Date: December 23, 2019

**ADDENDUM NO. 2**
To Project Bidding Documents for:

**A#03-119686**
**New Student Services Building**
**Compton Community College District**

tBP Project. No. 20987.00

## 2ND FLOOR POWER PLAN

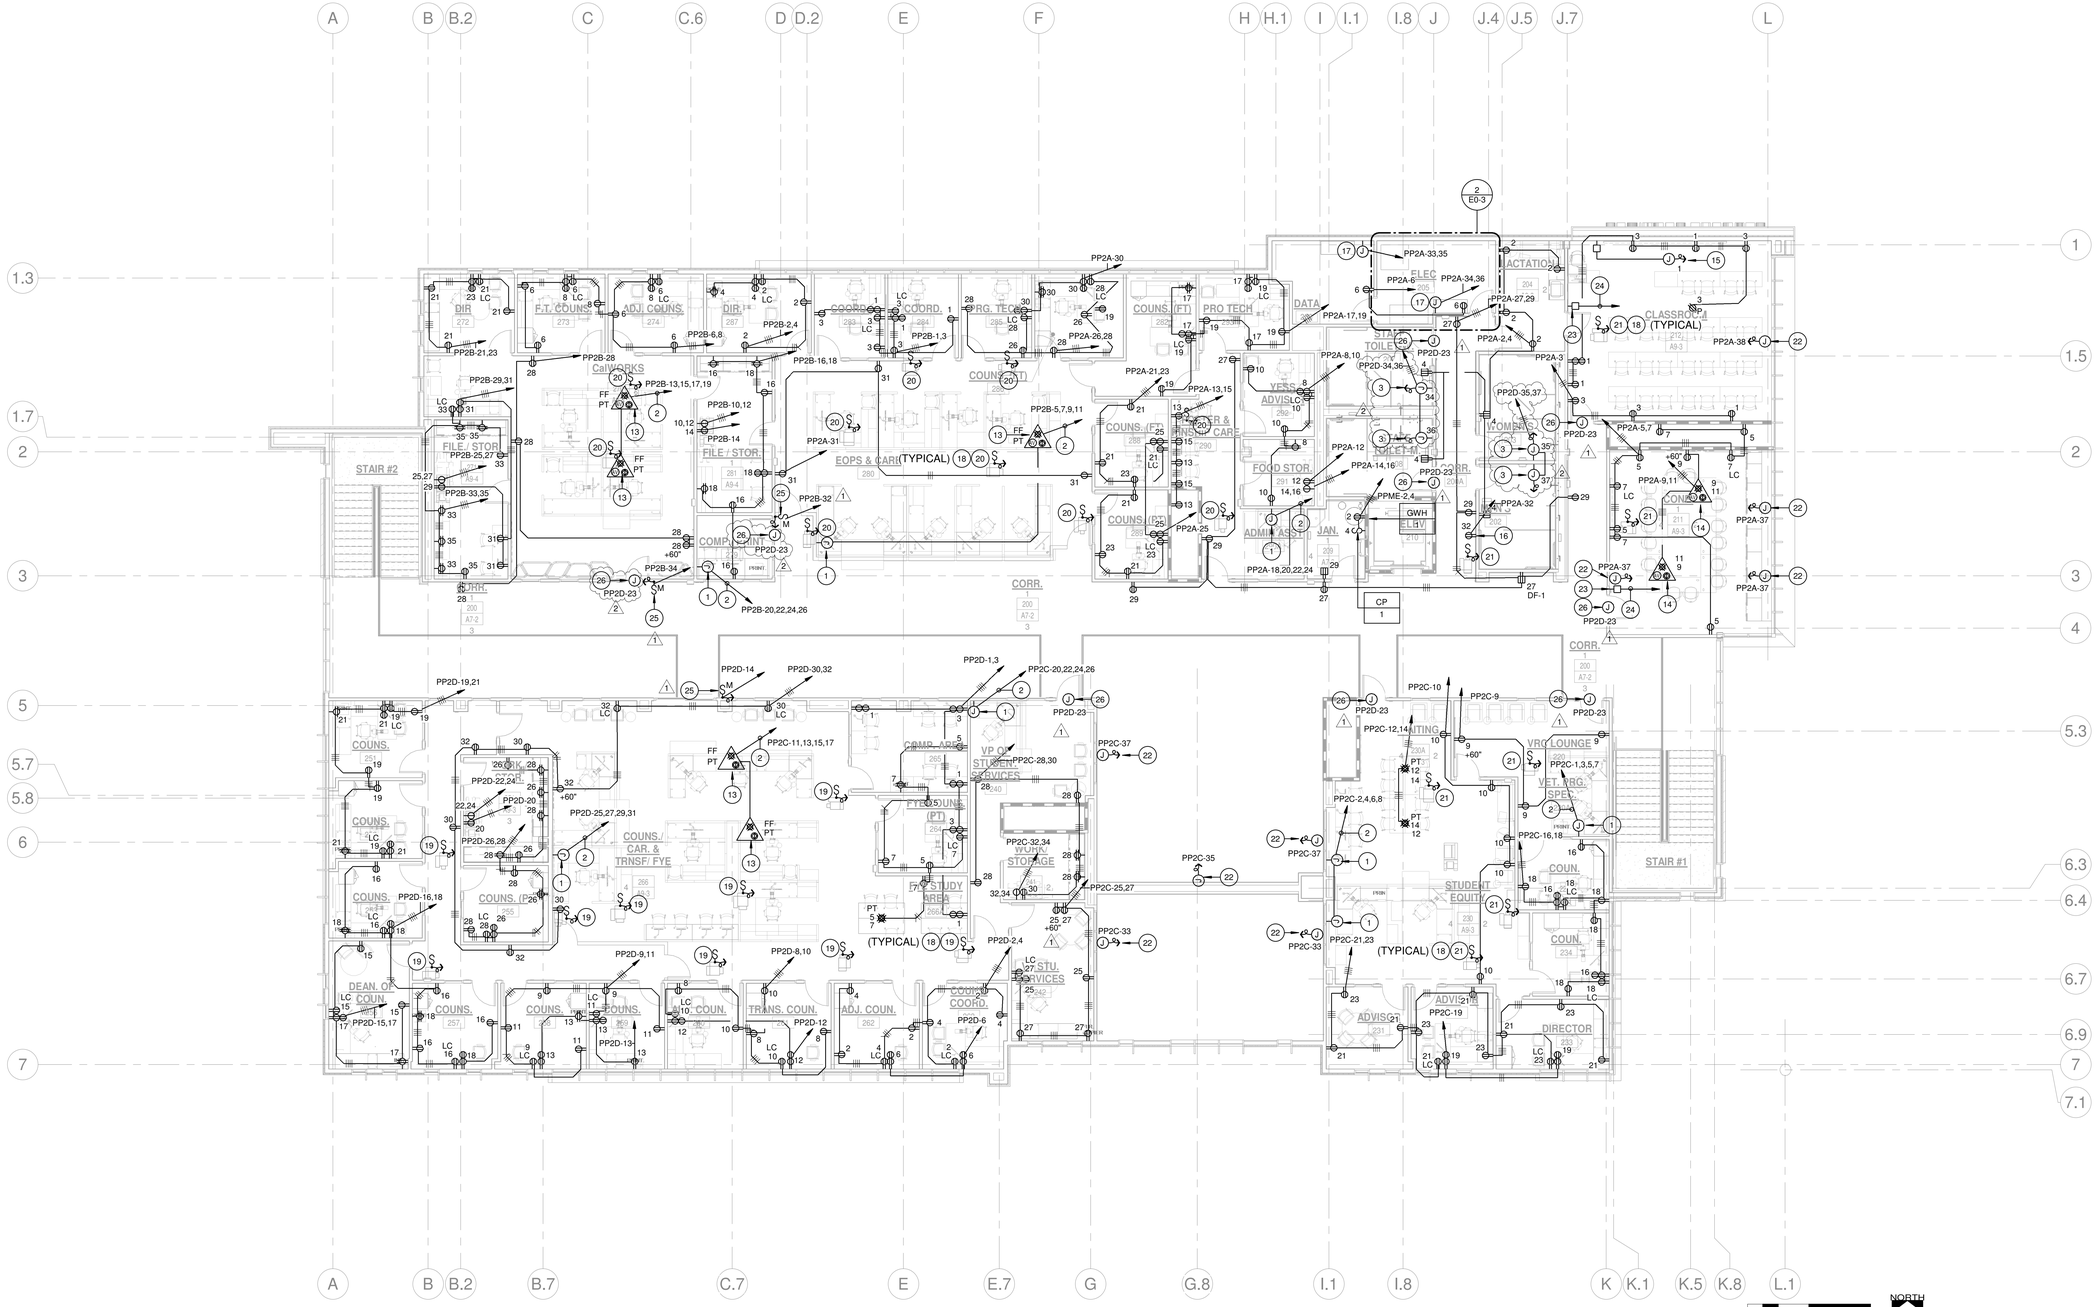
a. Add power for card readers at CalWorks 270, Comp/Print 279.
    b. Add power for electric hand dryers at Staff Toilet 207, Staff Toilet 208, Women's 203, Men's 202.

ENLARGED SITE TELECOM PLAN
SCALE: 1" = 60'-0"
0 15 30 60
NORTH

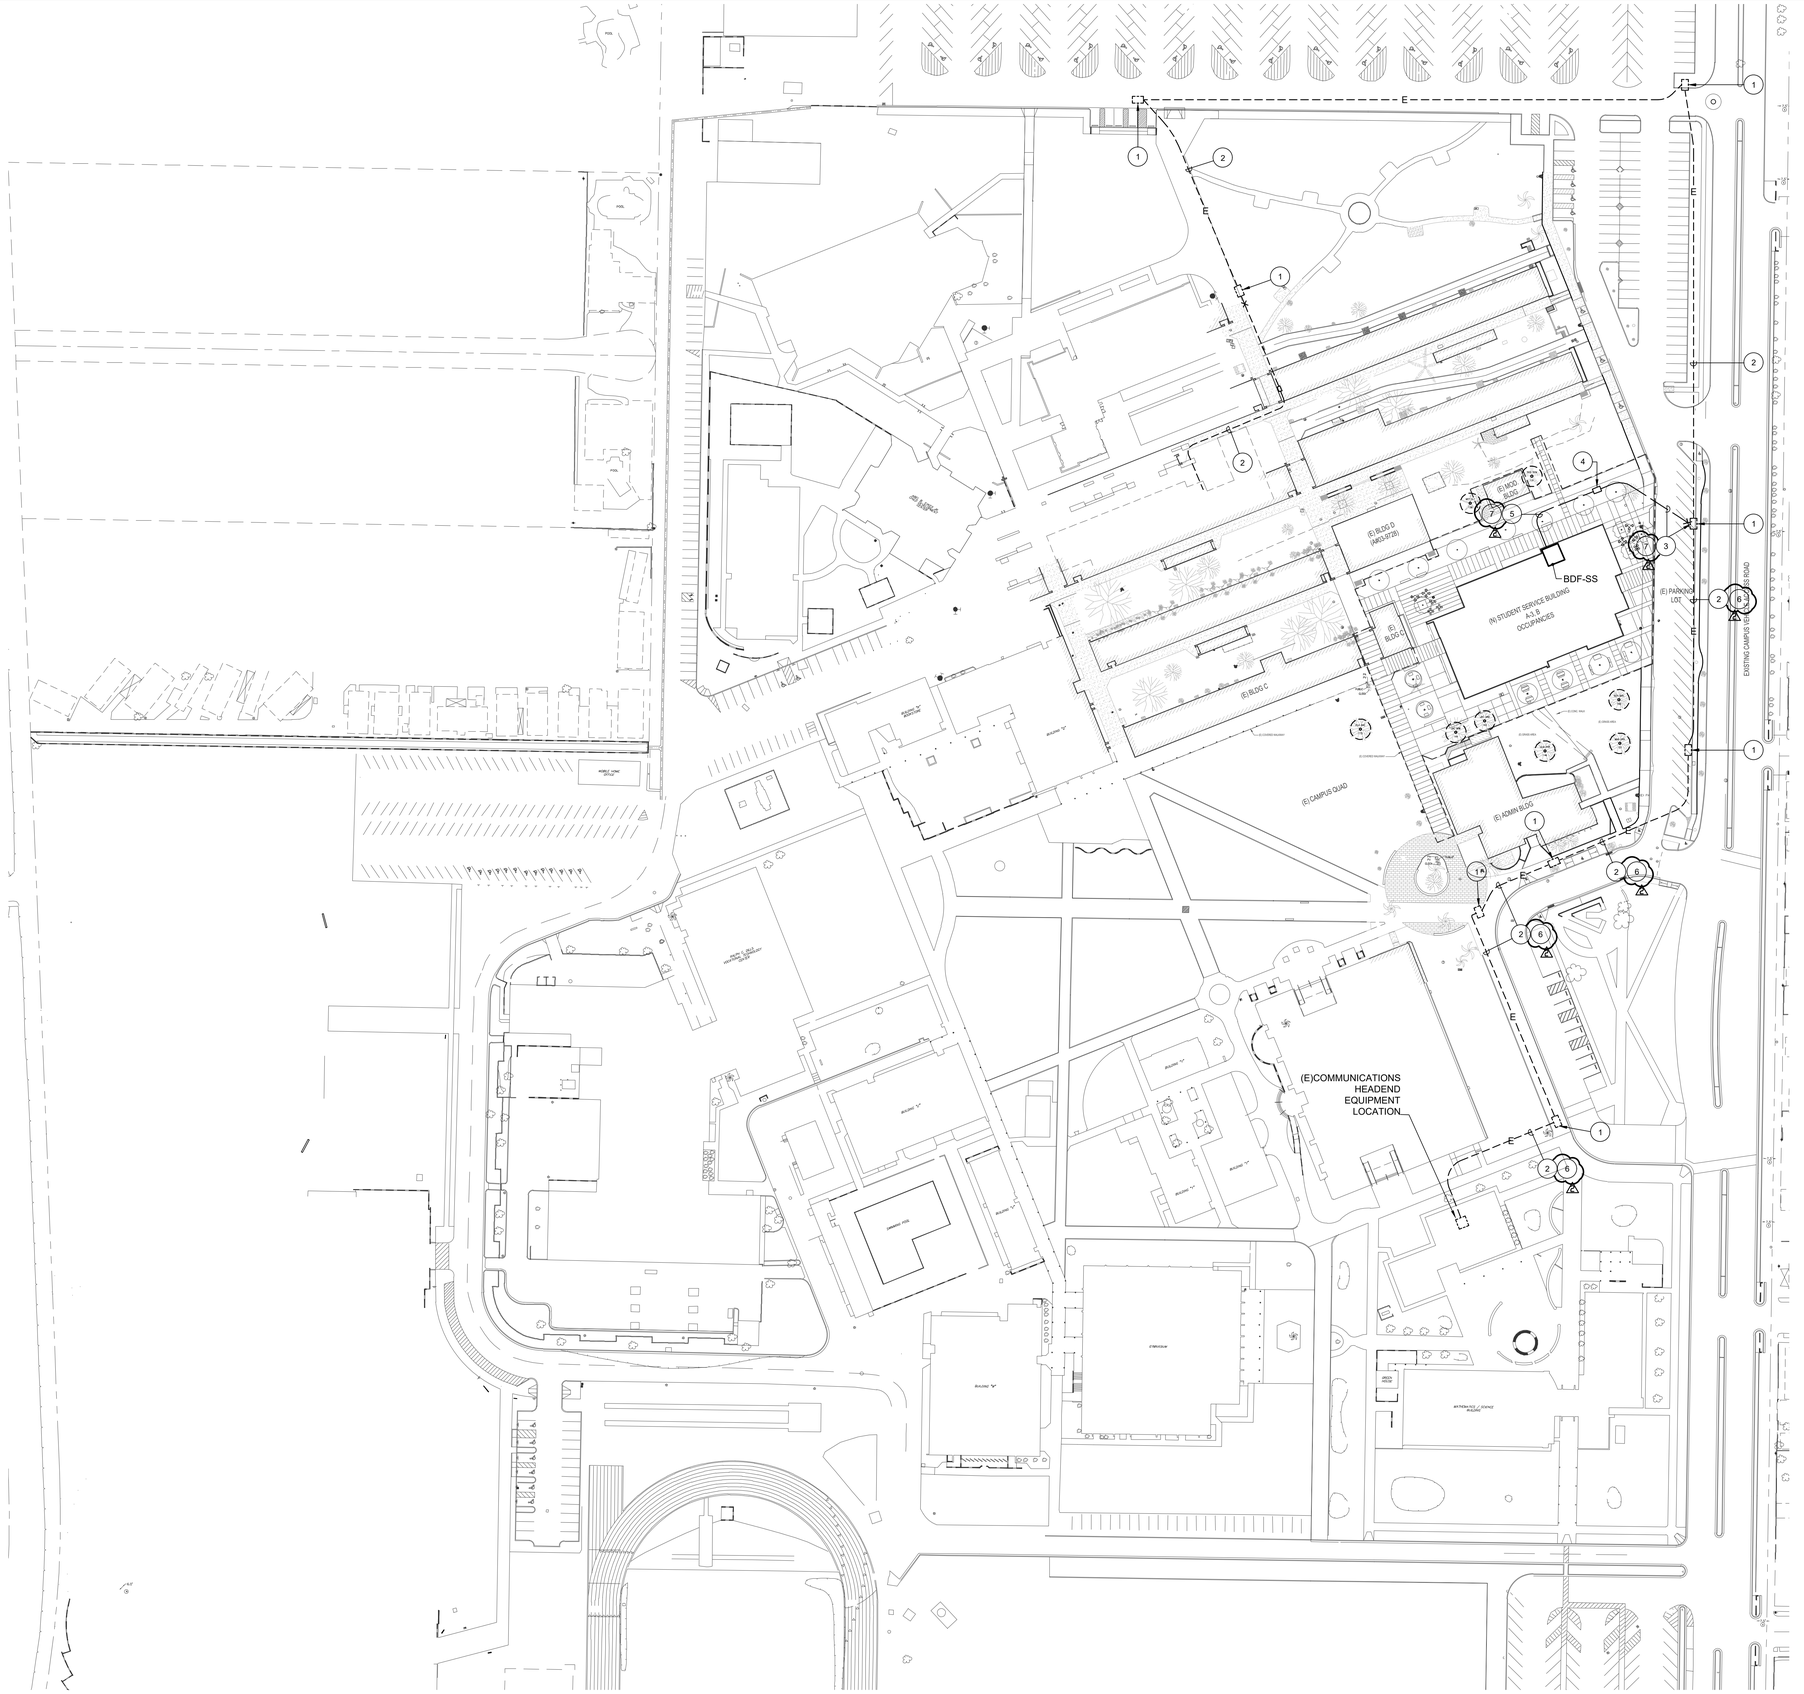
a. Revise Notes 3, 5, 6, 7 and update Telecom Site Plan.
